**BROCKMAN RESOURCES LIMITED
MARILLANA IRON ORE PROJECT
RESPONSE TO PUBLIC SUBMISSIONS
EPA ASSESSMENT NO. 1781**

RESPONSE TO PUBLIC SUBMISSIONS

EPA ASSESSMENT NO. 1781

APPENDIX 2: Figure 1.1

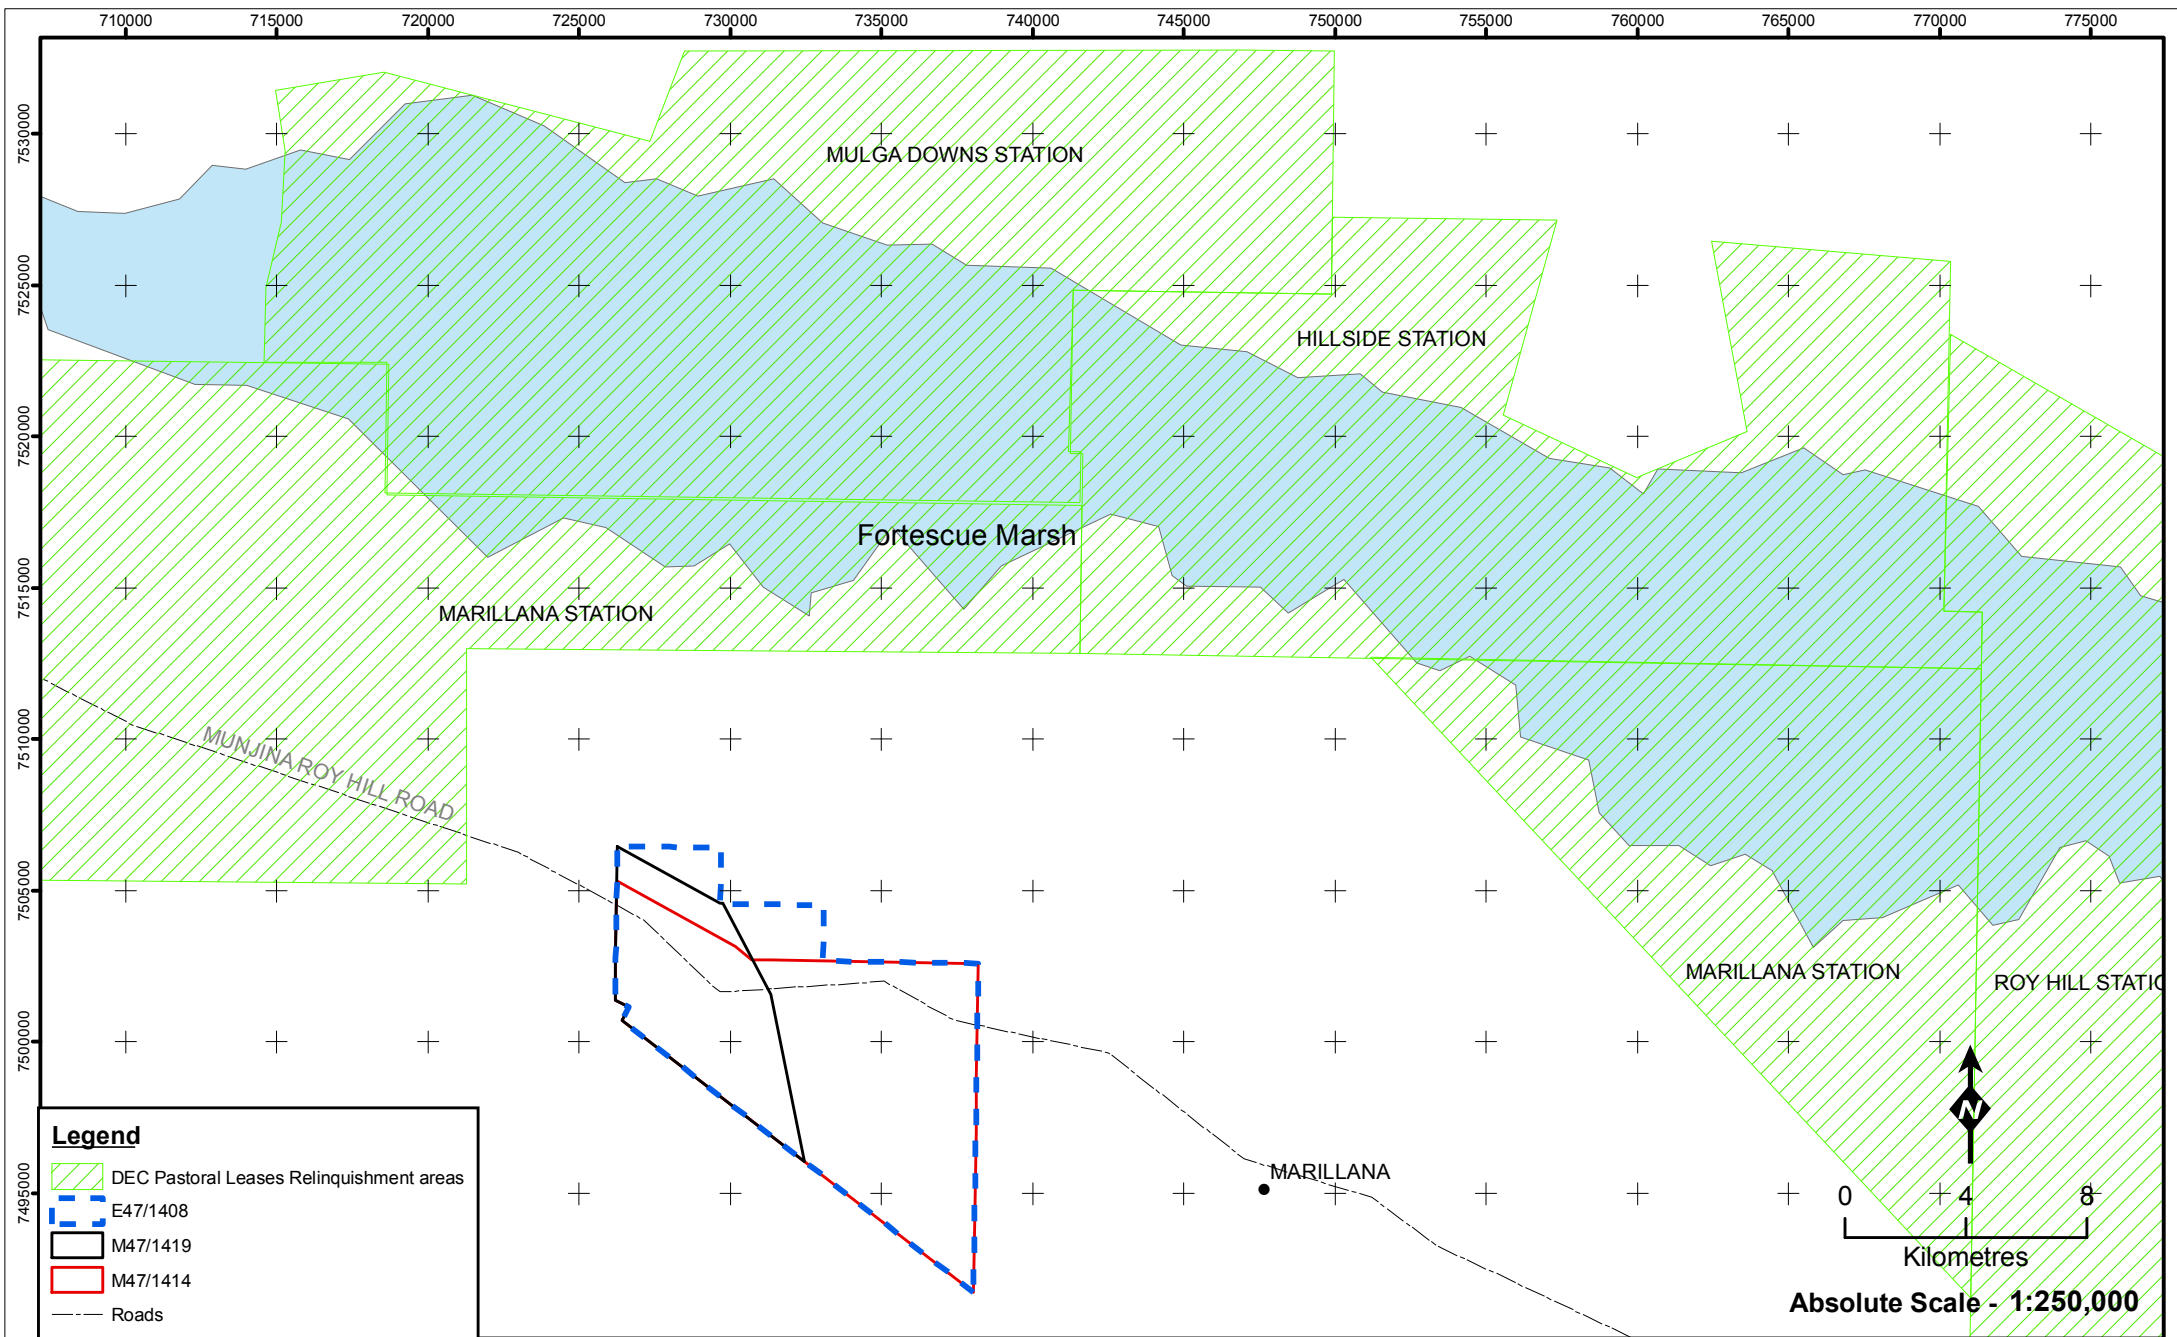
Submission Recommendation: (DEC2) That the proponent provides clear commitment to avoid indirect impacts of the project on the Fortescue Marsh 2015 area

The Fortescue Marsh is located approximately 15 km north of the Project area. The areas of current pastoral station which plan to be relinquished by the DEC in 2015 have been mapped and are shown in Figure 1.1 in Appendix 2 of this report. There are no areas of land related to the 2015 relinquishment zones which fall within the Brockman Marillana tenement.

The distance between the Fortescue Marsh boundary and the Marillana Project area is 15 kilometres. The distance between the 2015 relinquishment area boundary and the Marillana tenement is 12 kilometres. Whilst the area between the Marsh boundary and the 2015 exclusion area boundary was not directly addressed within the PER, in assessing indirect impacts of the Project on the Fortescue Marsh, the PER has considered the regional context which include this area.

Given the distance between the Project area and the 2015 relinquishment zones being approximately 12 kilometres away, there will be no direct or indirect impacts.
